PROJECT NAME: JUMBOLAIR HANGAR PHASE 2 COMPLEX

PROJECT NUMBER: 2024050073

APPLICATION: MAJOR SITE PLAN #32136

A MAJOR SITE PLAN
 FOR
JUMBOLAR PHASE 2 - HANGAR COMPLEX
 MARION COUNTY, FLORIDA
Project Area

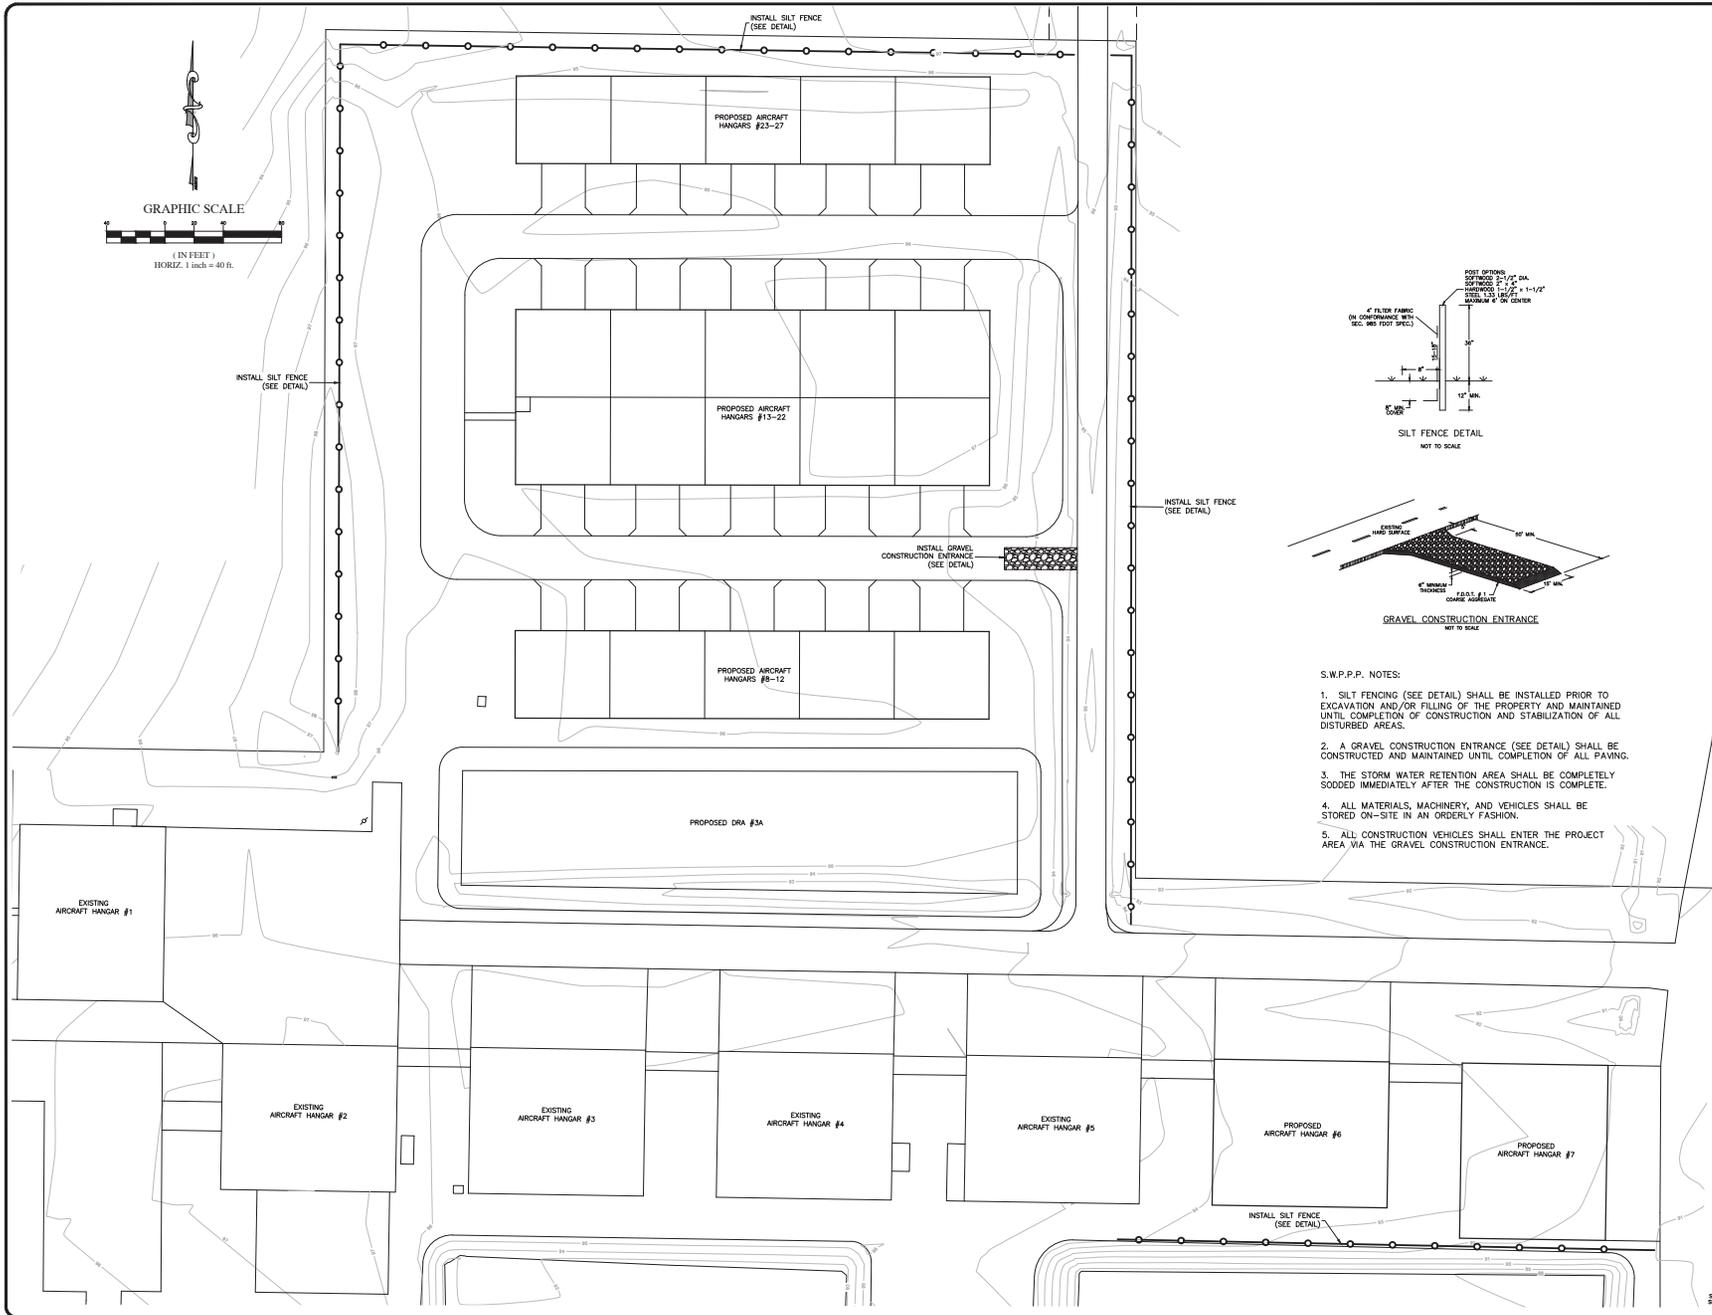
- 16 DEPARTMENT: 911 - 911 MANAGEMENT
REVIEW ITEM: Additional 911 comments
STATUS OF REVIEW: INFO
REMARKS: When it is time to pull Permits, please use Page C002-Project Area for your Site Plan since it shows the Parcels involved as well as the Access Road. Also, be sure to show and label NE 16th Ter.

- 33 DEPARTMENT: 911 - 911 MANAGEMENT
REVIEW ITEM: 2.12.28 - Correct road names supplied
STATUS OF REVIEW: NO
REMARKS: Sheet C002 is missing the road and label for NE 16th Ter.
